This Service Information bulletin supersedes SI B11 11 12 dated November 2012.

**NEW** Recall Campaign 12V-550:: Replace Hex Bolt with Internal Thread for Deflection Pulley

E70 with M57Y engine

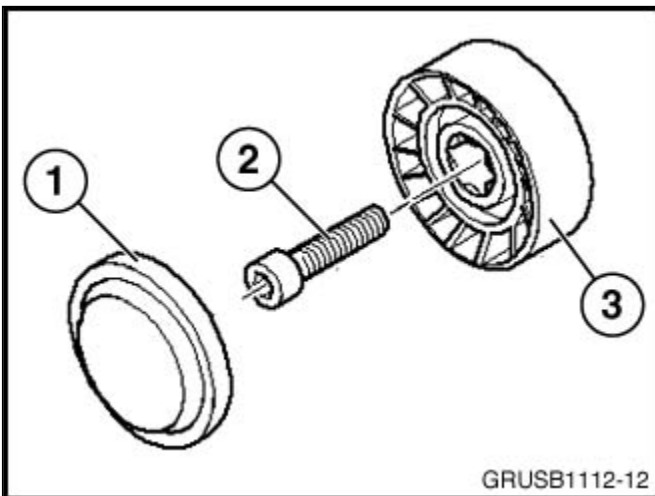
3. **NEW** Remove cover (1) from deflection pulley (2) to access the mounting bolt.

4. **NEW** Remove the deflection pulley mounting bolt (2) to remove the deflection pulley (3).

Overview:

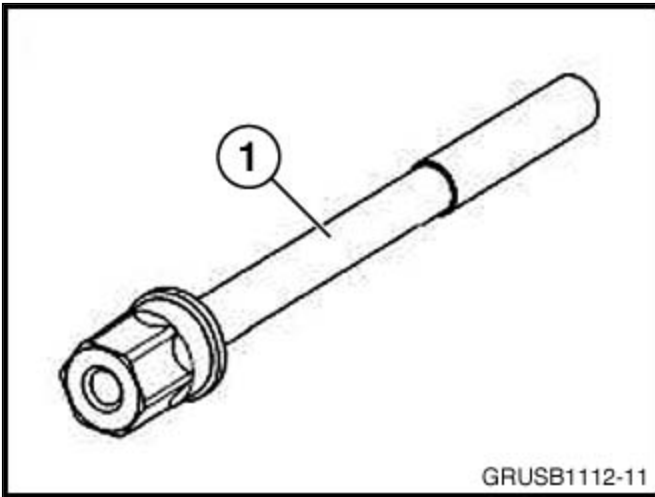
5. **NEW** Remove and replace the alternator bolt with P/N 12 31 8 574 809 (M10x125). Do not remove the alternator.

Torque the new bolt to 38 Nm initial torque, and then angle

toque the bolt to an additional 180°.
